NL-13-1460

Vogtle Electric Generating Plant – Units 1 and 2
Southern Nuclear Operating Company Response to the
Request for Additional Information Regarding Overall Integrated Plan for
Reliable Spent Fuel Pool Instrumentation (Order Number EA-12-051)

**Vogtle Electric Generating Plant – Units 1 and 2
Southern Nuclear Operating Company Response to the
Request for Additional Information Regarding Overall Integrated Plan for
Reliable Spent Fuel Pool Instrumentation (Order Number EA-12-051)**

ATTACHMENT 1 SKETCH IN RESPONSE TO RAI ITEM 1.b

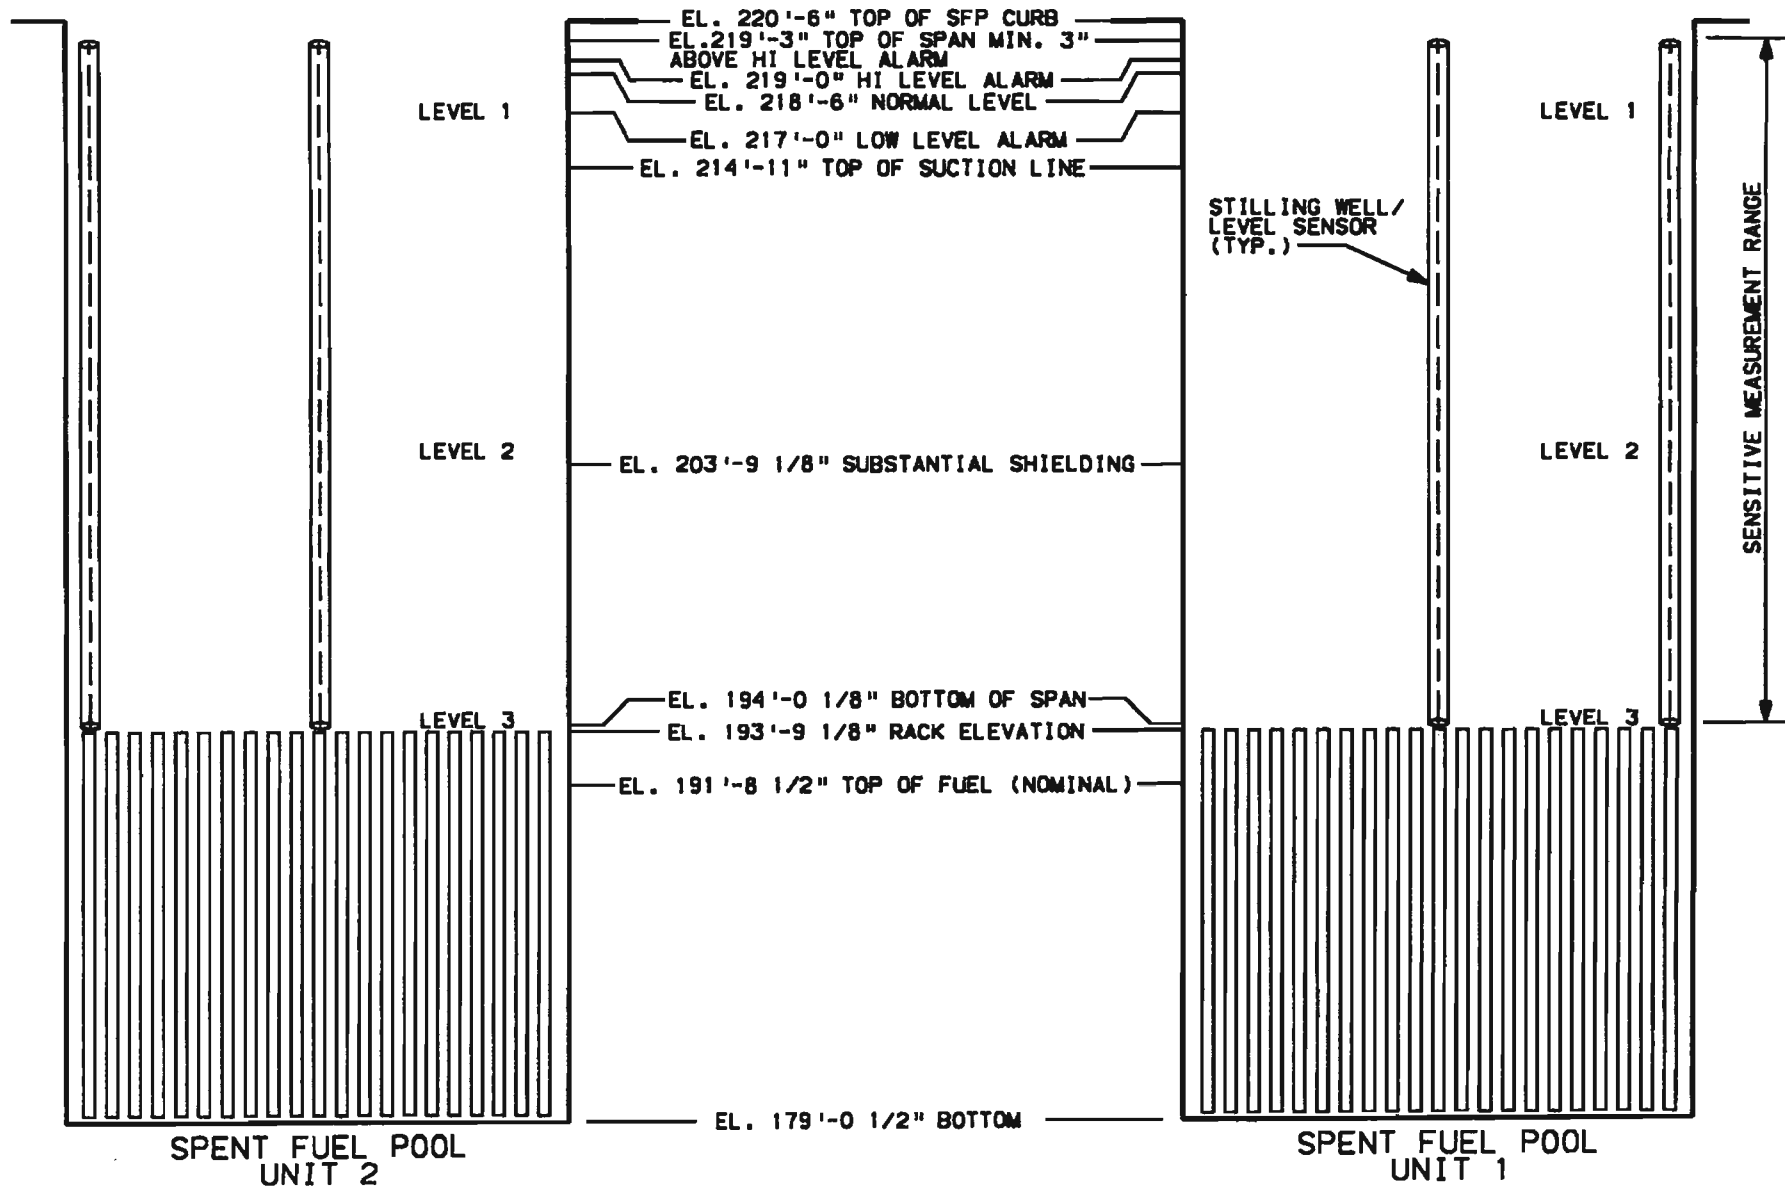
- a) For Level 1, specify how the identified location represents the HIGHER of the two points described in the NEI 12-02 guidance for this level.
- b) A clearly labeled sketch depicting the elevation view of the proposed typical mounting arrangement for the portions of instrument channel consisting of permanent measurement channel equipment (e.g., fixed level sensors and/or stilling wells, and mounting brackets). Indicate on this sketch the datum values representing Level 1, Level 2, and Level 3 as well as the top of the fuel. Indicate on this sketch the portion of the level sensor measurement range that is sensitive to measurement of the fuel pool level, with respect to the Level 1, Level 2, and Level 3 datum points.

Enclosure 2 provides a sketch that depicts an elevation view of the Unit 1 and 2 SFP. The sketch depicts the datum values representing Level 1, Level 2, and Level 3, as well as the top of the SFP rack. Per NEI 12-02, Level 3 corresponds nominally (i.e., +/- 1 foot) to the highest point of any rack seated in the spent fuel pool. The top of the fuel elevation that is shown on the sketch is a nominal value that varies depending upon the specific fuel assembly type and fuel bundle attachments. The level sensor sensitive measurement range will span from a minimum of 3 inches above the high SFP level alarm setpoint to 3 inches above the top of the spent fuel pool rack.

SECTION OF DWG
AX2D09A011

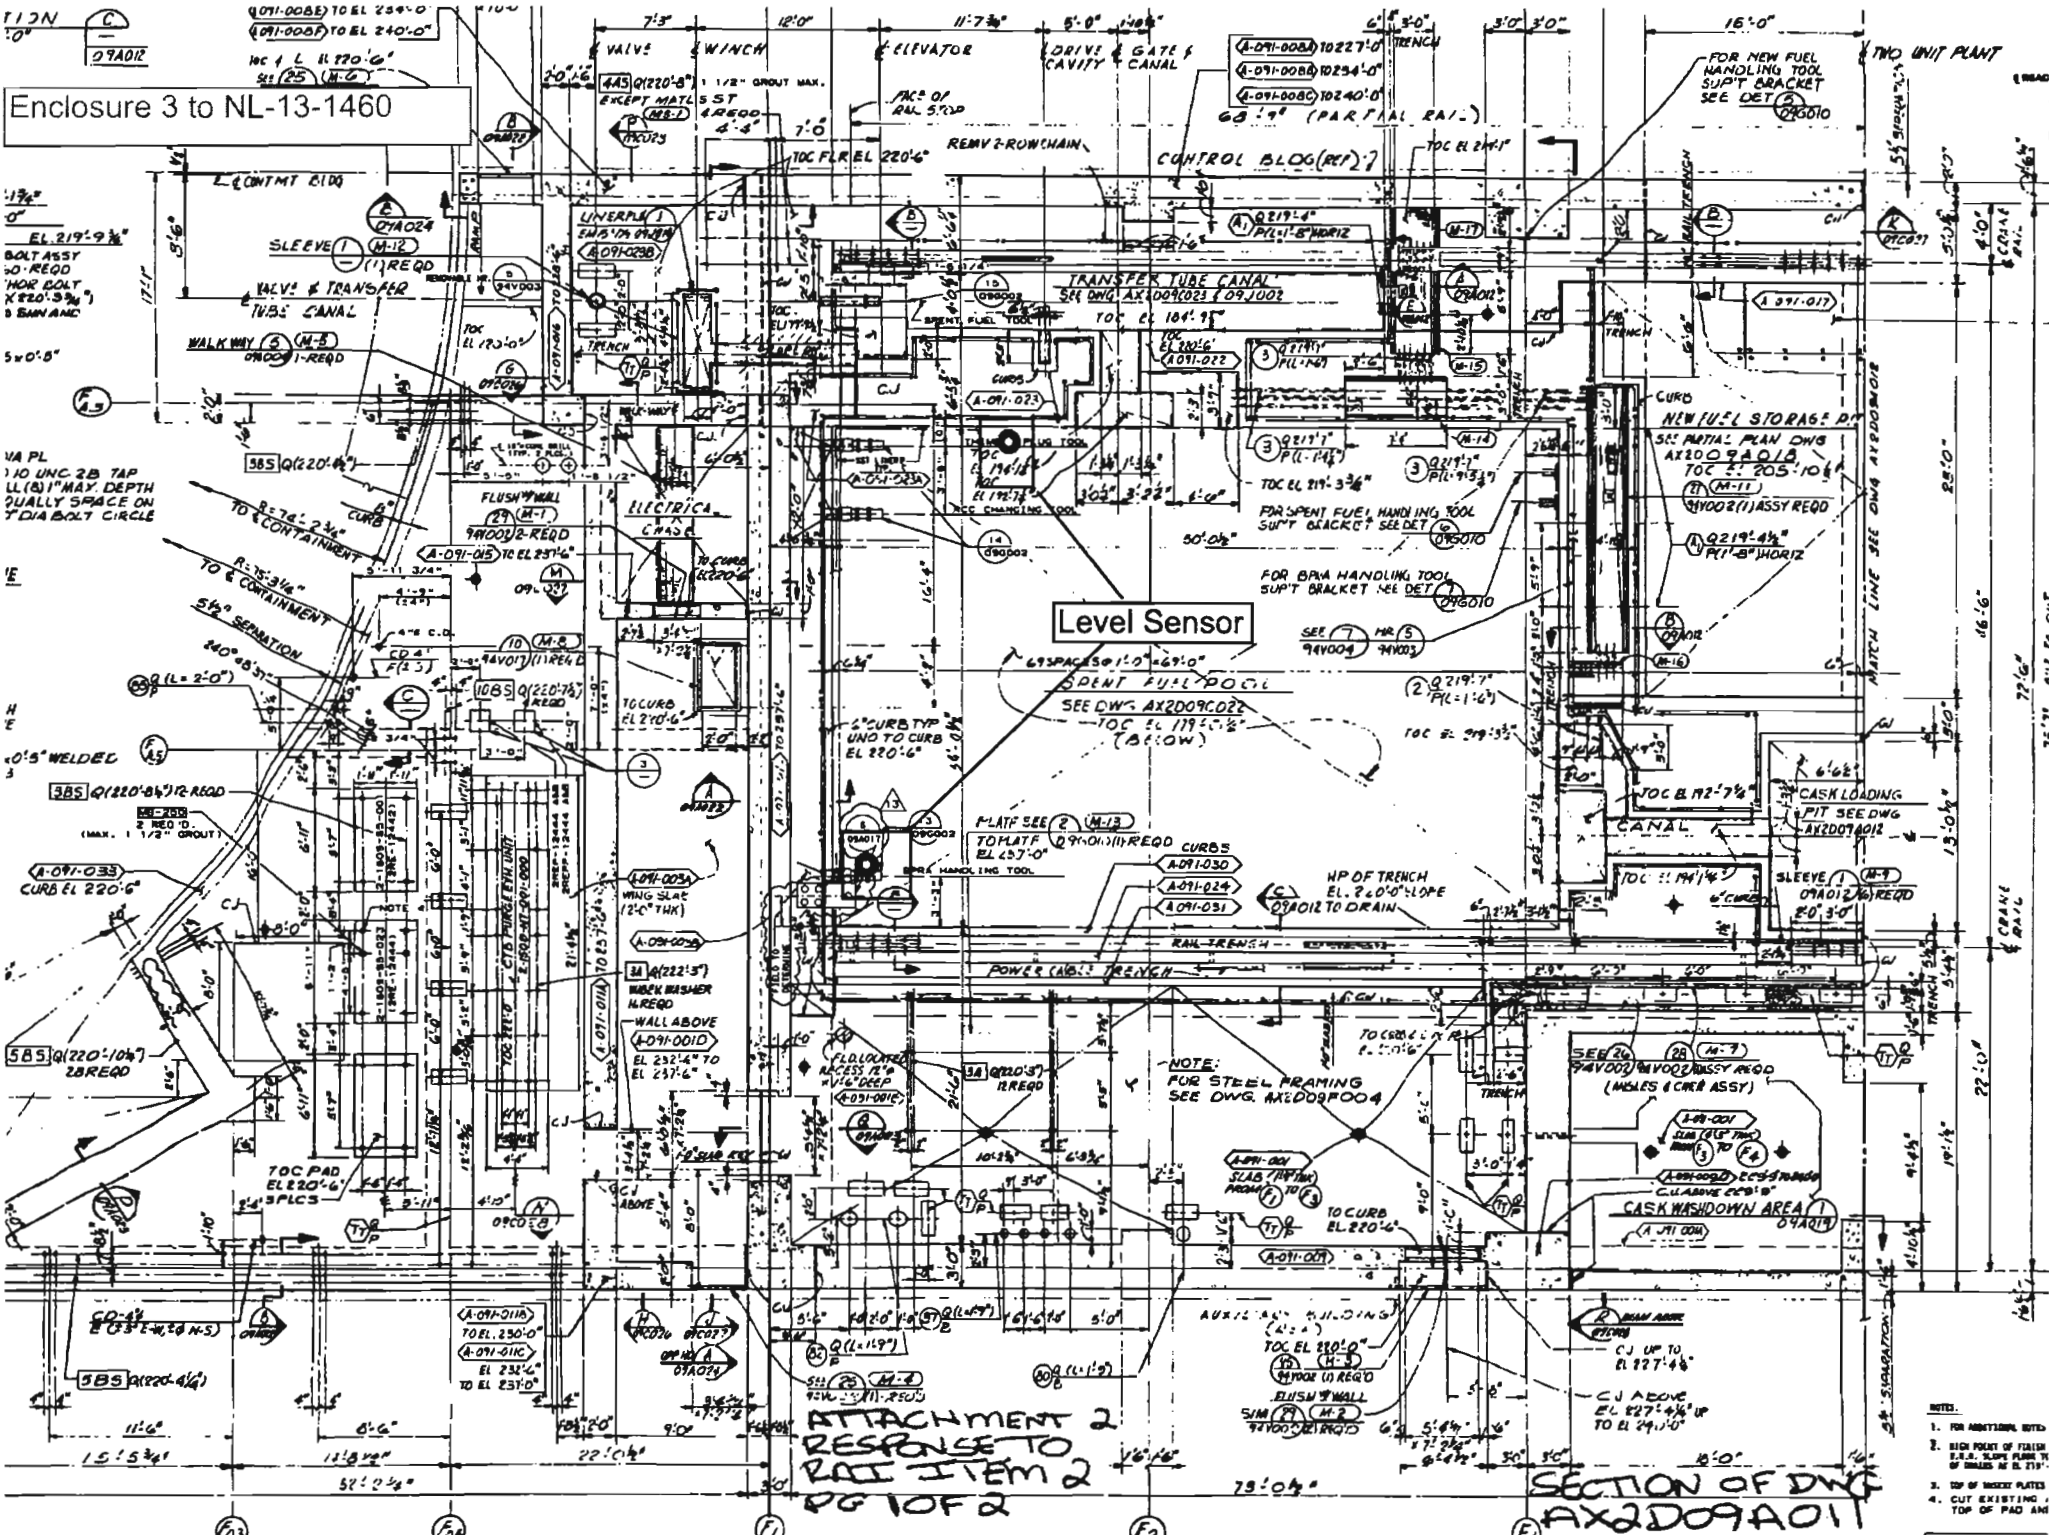
Please provide a clearly labeled sketch or marked-up plant drawing of the plan view of the SFP area, depicting the SFP inside dimensions, the planned locations/placement of the primary and back-up SFP level sensor and mounting brackets, and the proposed routing of the cables that will extend from the sensors toward the location of the read-out/display device.

Enclosure 3 depicts a section of marked up plant drawings AX2D09A011 and AX2D09A012. This attachment shows a plan view of the SFP area of each unit. The drawings show inside dimensions for the SFPs and the anticipated locations of the level sensors and associated mounting brackets (identified by the circle inside the square box). There is no designated primary or backup sensor as both serve an equal purpose. The routing of the instrument cables from the sensors to the display device will be determined after a location for the display unit has been finalized. SNC intends to provide specific SFP area cable routing information in the February 2014 Overall Integrated Plan 6 month update.
